37/03-06HHH 7314 BALTIMORE AVE

Takoma Park Historic District

From: Fothergill, Anne
Sent: Thursday, June 14, 2007 10:42 AM
To: 'rl-hbr@verizon.net'
Subject: 7314 Baltimore

SUBJECT: Historic Area Work Permit #435405, window replacement, deck construction, and front porch alterations

SHEET 1Bx

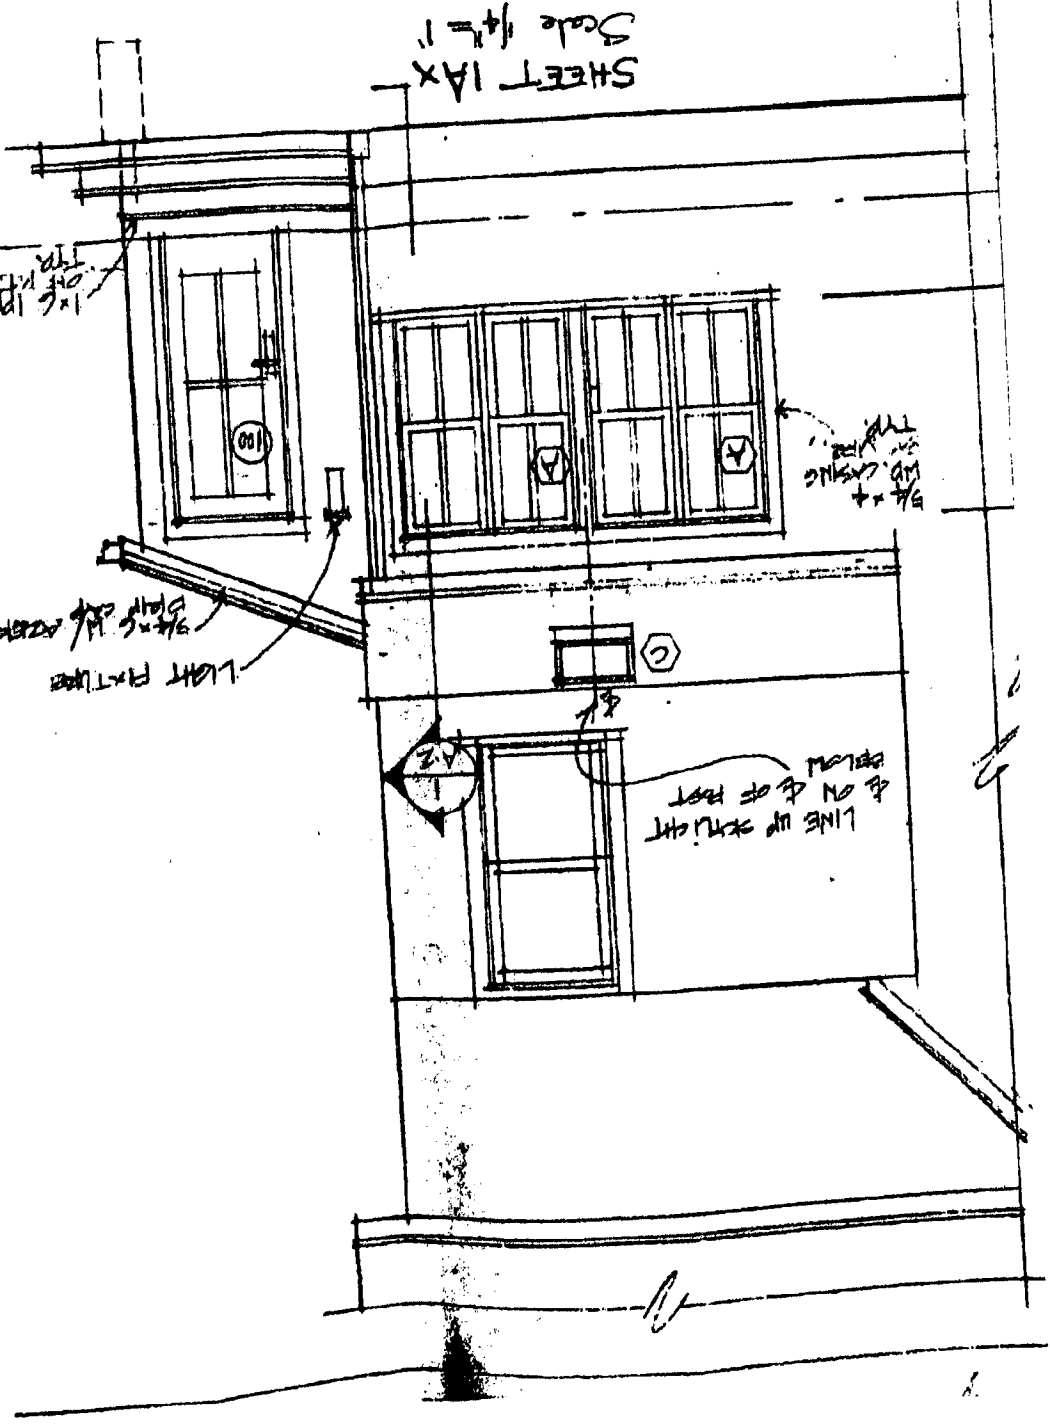
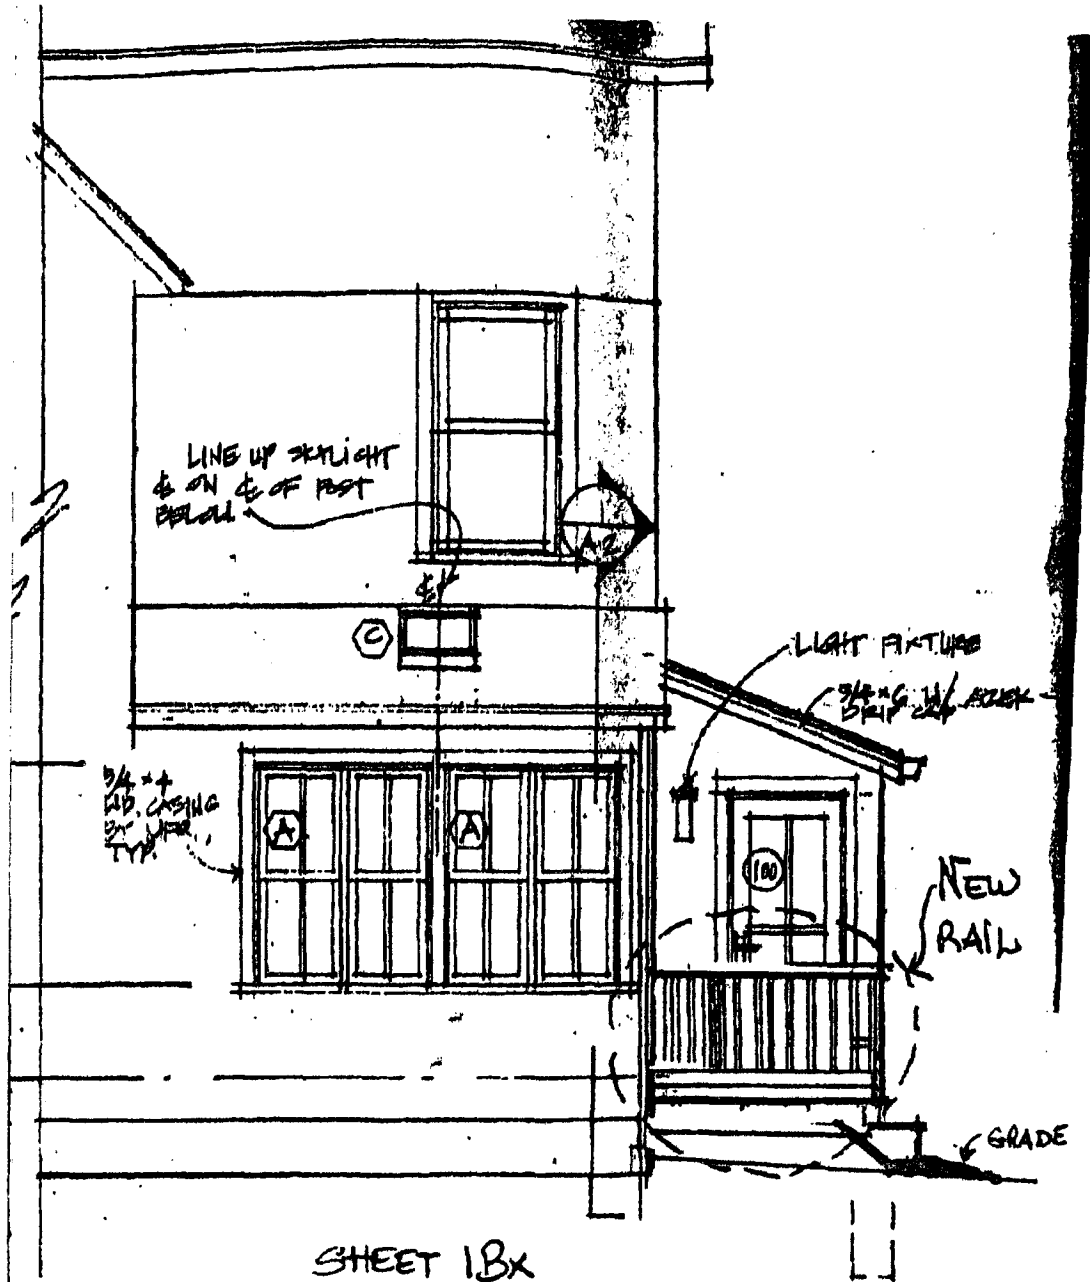
The HPC has agreed to the proposed change for the approved rear deck at 7314 Baltimore. The proposed wood inset picket railing has been approved at the staff level. Please keep this email for your files and we will keep a copy of "Sheet 1Bx" that you sent June 13, 2007 as the approved side elevation for our files.

SHEET 1A_x SHOWS THE VERSION YOU APPROVED. SHEET 1B_x SHOWS THE REVISED RAIL ON THE Rear PORCH.

Approved

npc ok to approve at
street level
